**ITEM V-A: REGIONAL MALL MASTER SIGN PERMIT MODIFICATION – 1151 GALLERIA BOULEVARD – GALLERIA AT ROSEVILLE, NCRSP PARCEL 35 – FILE# 2007PL-183 (PROJECT# PSP-000070)**

The applicant requests approval to modify the approved Regional Mall Master Sign Permit (RMMSP) for the Galleria Mall. Proposed changes include updating the graphic design, adding new on-site directory signage, and adding criteria to address signage for the expanded retail areas and parking garages.

**Figure 1 – Pylon Sign**

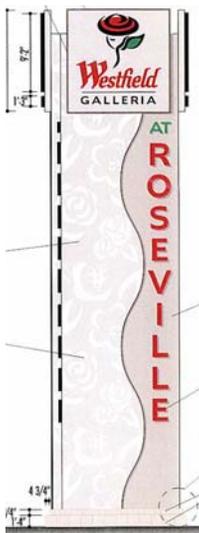
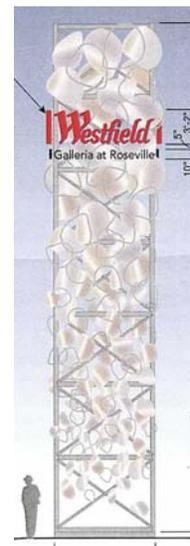
- **Page 10.06 – Main Pylon Sign (Sign AA1):** This sign is located at the northwest corner of Galleria Boulevard and Roseville Parkway. The existing sign is 46 feet tall and is clad with brushed aluminum and overlaid with white rose graphics containing the Westfield logo at the top and the words "at Roseville" in vertical text down the right side of each face. The existing sign structure will be re-clad to feature aluminum petals and petal outlines of various sizes. The petals will be slightly bent to provide dimension and will be attached to the steel frame with mesh. The redesigned Westfield logo will be located on each face near the top of the sign. See Figure 1 below for illustrations of both the existing and proposed signs.

**Figure 2.1 –Existing Entry Monument Signage**

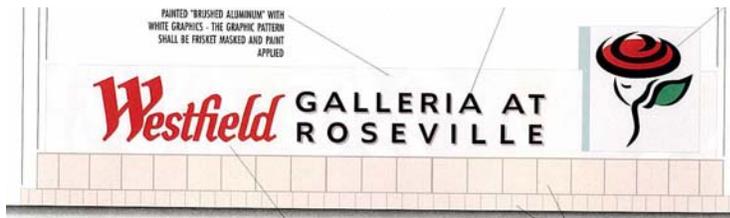
- **Page 10.07 - Entry Monument Signs (Signs AA2):** There are currently eight (8) entry monument signs located at the Mall, with two (2) at each major entrance from Roseville Parkway and Galleria Boulevard. The applicant proposes to replace these eight (8) signs with four (4) entry monument signs, with one (1) located at each major entrance to the mall (Signs AA2 on the Site Location Plan).

The background of the existing signs are brushed aluminum with white rose patterned graphics overlaid with the Westfield logo and a red rose graphic. The existing monument signs are 198 square feet each. The proposed signs will be constructed of brushed aluminum petal shaped sign panels that are curved to provide dimension. The design of the proposed monument signage is consistent with the proposed pylon sign shown above. The monument signs will be 166 square feet each, 32 square feet smaller than the existing. The eight (8) existing entry monument signs total 1,584 square feet of sign area. The proposed four (4) entry monument signs will total 664 square feet of sign area. Figure 2 below illustrates the existing and proposed entry monument signage.

**Figure 3 – Plateau Deck Parking Garage Signage**

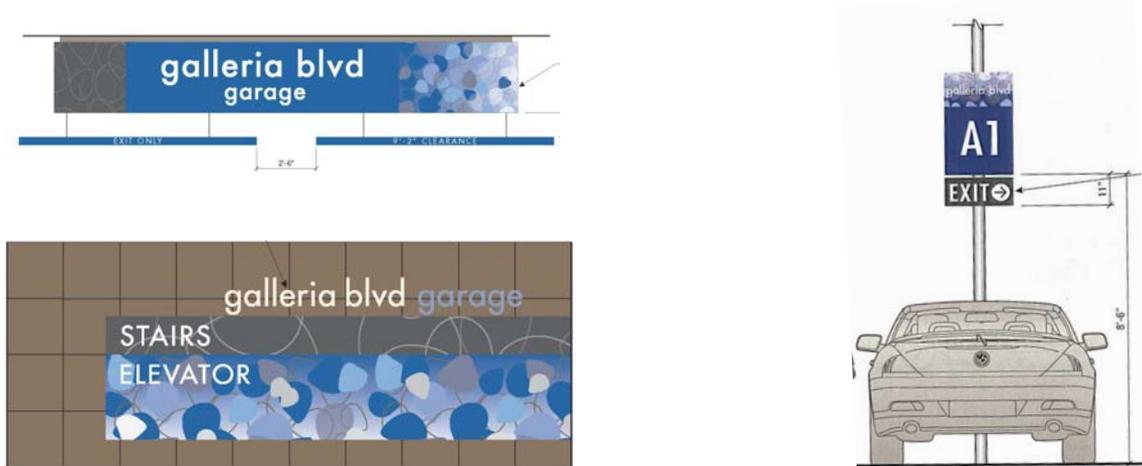
- **Plateau Deck (pages 50.01 – 50.09):** The applicant proposes new sign criteria to address center identification signage on the exterior of the parking garage and directional signage on the interior of the parking garage. There will be one (1) exterior "Westfield" sign located on the east side of the garage, facing Galleria Boulevard, directly over the vehicle entrance (see page 50.01 for exact

location and page 50.03 for elevations of the proposed Westfield logo). The directional signage is shown on pages 50.04 through 50.09 and select illustrations are provided in Figure 3 below. As shown, the petal theme is carried over into the parking garage signage and compliments the pylon and entry monument signage shown above.

**Figure 7 – Directional Signs**

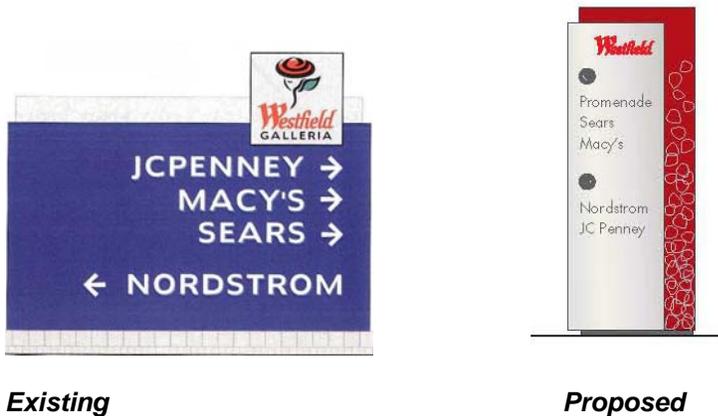
- **Page 10.01 - Primary Directional Signs (Signs AD1 & AD2):** There are nine (9) new vehicle directional signs proposed throughout the Mall site to replace the existing five (5) directional signs. They are generally located along the ring road around the mall, on the side of the road that is interior to the Mall, near the drive aisle entrances to the parking fields. See Figure 7 below for illustrations of the proposed and existing directional signs.

The existing directional signs are 56.5 square feet. The proposed signs are 30-square feet and serve as a way finding measure. They be brushed aluminum with black text on the sign face. Each sign will list anchors and amenities such as Macy's, Nordstrom, The Promenade, etc. and will have an arrow pointing the direction to each. The sign casing will be identical to the casing shown in Figure 6 above (painted the deep red with the petal overlay). The total area of the current directional signs is 283 square feet. The total area of the proposed directional signs is 270 square feet.
